Proposed Development of
Boco Rock Wind Farm
South-Eastern, New South Wales

Preferred Project Report
and Response to Submissions

May 2010

Prepared for Boco Rock Wind Farm Pty Ltd by Wind Prospect CWP Pty Ltd

Figure 7 Proposed Road Alignment in the Yandra Cluster
(A3 size version of this Figure is displayed in Appendix A)

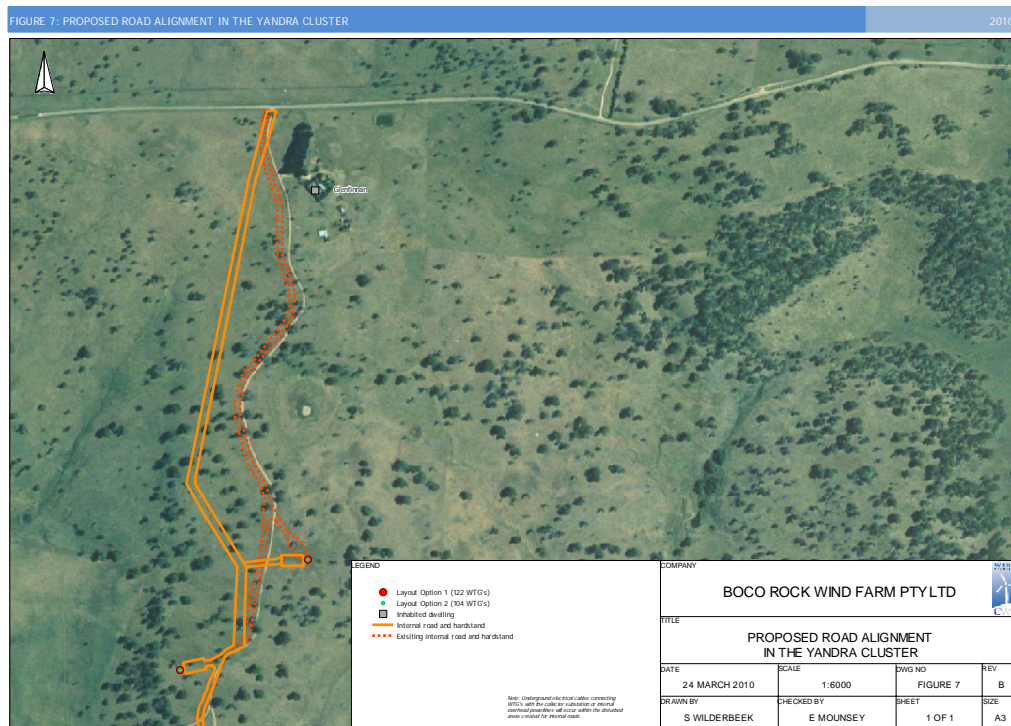
SoC099 – A commitment to avoid hollow-bearing trees wherever possible during micro-siting has been made. A recent amendment to the proposed road alignment on the Yandra cluster has been made to minimise impacts on hollow-bearing trees (see Figure 7 below). This area was shown to DECCW during the 4 March site inspection.

shown in Figure 3.3A) has been modified to follow the legal Council road reserve in order to minimise the impact of that section of track on hollow-bearing trees.
